Access Compliance Report

Public Rights-of-Way

(Curb Ramps)

Intersection ID: 2984	Main Street: THOMAS_RIDGE_DR	Cross Street: WAVERLY_LYNN_LN	Location: SW
ADA ID: 883C8E142861	Ramp Type: BlendTrans1	Initial Pass/Fail: Fail	Overall Compliance: No
		Severity Score: 1.25

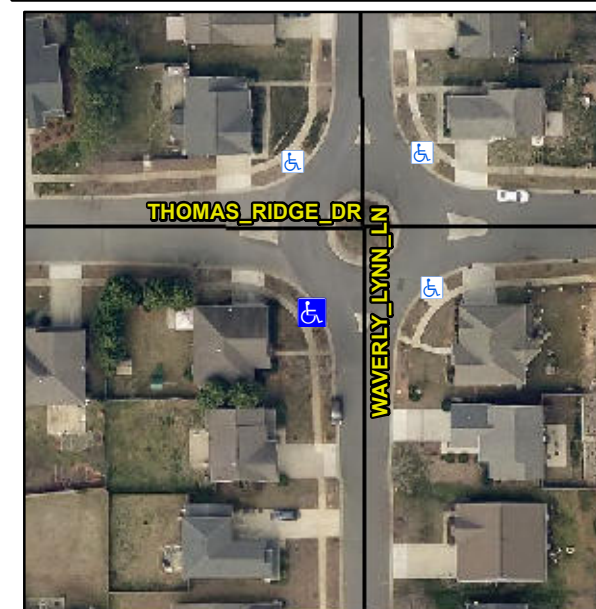
Compliance	Description	Data	Compliance	Description	Data
N/A	Ramp Length (in)	85.5	Yes	BlendTrans Slope (%)	4.6
Yes	Ramp Width (in)	147.0	No	BlendTrans XSlope (%)	2.3
N/A	Flare Type LT	N/A	N/A	Flare Type RT	N/A
N/A	Flare Slope LT (%)	N/A	N/A	Flare Slope RT (%)	N/A
N/A	Flare Traversable LT?	N/A	N/A	Flare Traversable RT?	N/A
N/A	Landing Length (in)	N/A	N/A	DWS Provided?	N/A
N/A	Landing Width (in)	N/A	N/A	DWS Contrast?	N/A
N/A	Landing Slope (%)	N/A	N/A	DWS Length (in)	N/A
N/A	Landing X Slope (%)	N/A	N/A	DWS Full Width?	N/A
N/A	Landing Curb? (Y/N)	N/A	N/A	DWS Offset (in)	N/A
N/A	Shared Landing?	N/A			
N/A	Gutter Ponding?	N/A	N/A	Gutter Slope (%)	N/A
N/A	Gutter Lip Ht (in)	N/A	N/A	Gutter X Slope (%)	N/A
N/A	Painted X Walk1?	No	N/A	Painted X Walk2?	No
	X Walk 1 Direction	To E		X Walk 2 Direction	To N
	X Walk 1 Width (in)	N/A		X Walk 2 Width (in)	N/A
	X Walk 1 Slope (%)	1.4		X Walk 2 Slope (%)	0.5
	X Walk 1 X Slope (%)	0.1		X Walk 2 X Slope (%)	1.4

Remove & Replace Curb Ramp With Two New Directional Ramps or Equivalent.

R304.5.3
